Release Note. (CP4 3.6.1)

date : 2022.04.18

1. **BASE VERSION** : CP4_3.6.0
2. **H/W** : CP4, CP4S
3. **Changes/New**
4. **Fixed**
 - 1) Rare bug when opening SD Card door when buffer is full. When unlock the SD Slide Lock, buffer full issue.

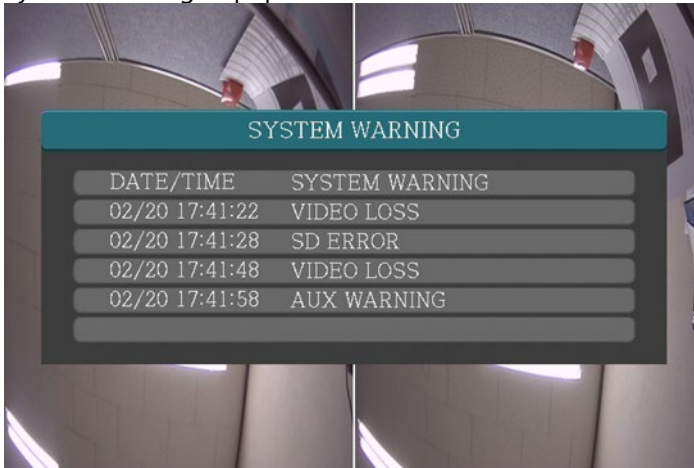
- 15) PANIC event is available on menu and popup screen.

PANIC event is activated when pressing the button more than 1 second.

- xi. Available on Event Menu

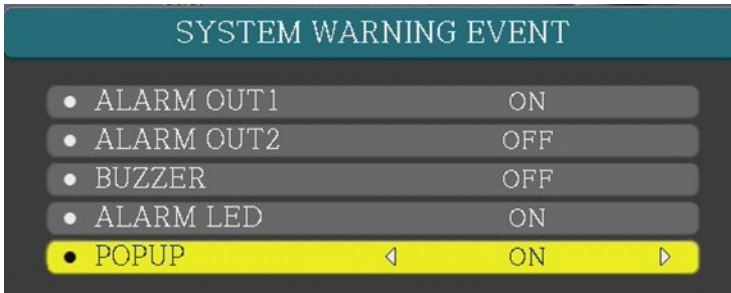
- Duration is initialized when another event is occurred within the duration.
- The list is initialized after the duration.
- vi. Pop-up window and warning list are initialized when pressing ESC button.
- vii. Pop-up window is not removed even the warning event is recovered.
- viii. Warning is displayed again when the event is occurred again from recovery.
- ix. System warning pop-up windows is only available on Live screen.
 - It is not available on Playback, Menu, another pop-up window on Live.
 - In the above condition, pop-up window is not displayed and event is not recorded, neither.
- x. System Warning Popup Windows

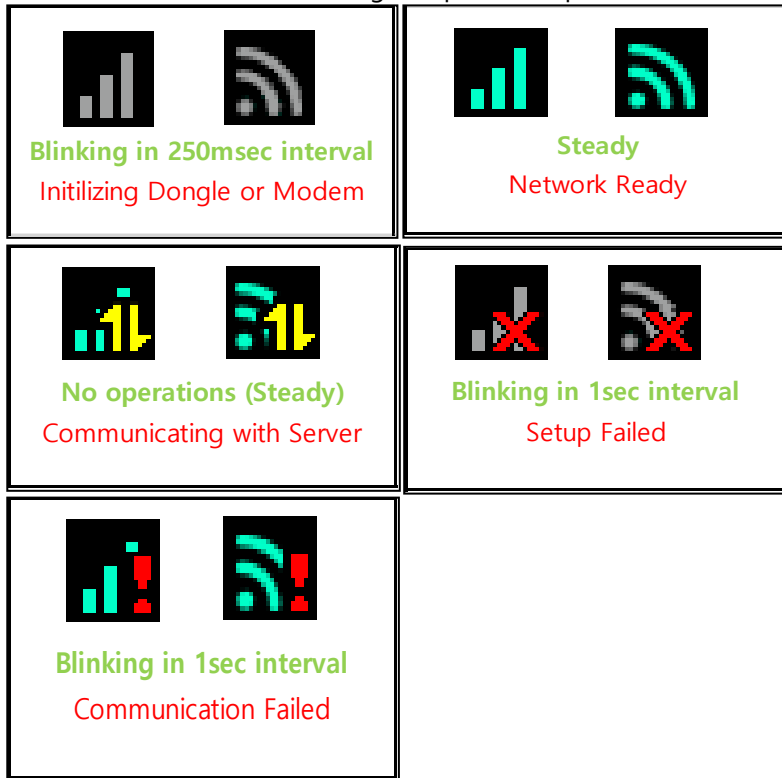
- 1) Network Status Icon and LED signal operation updated
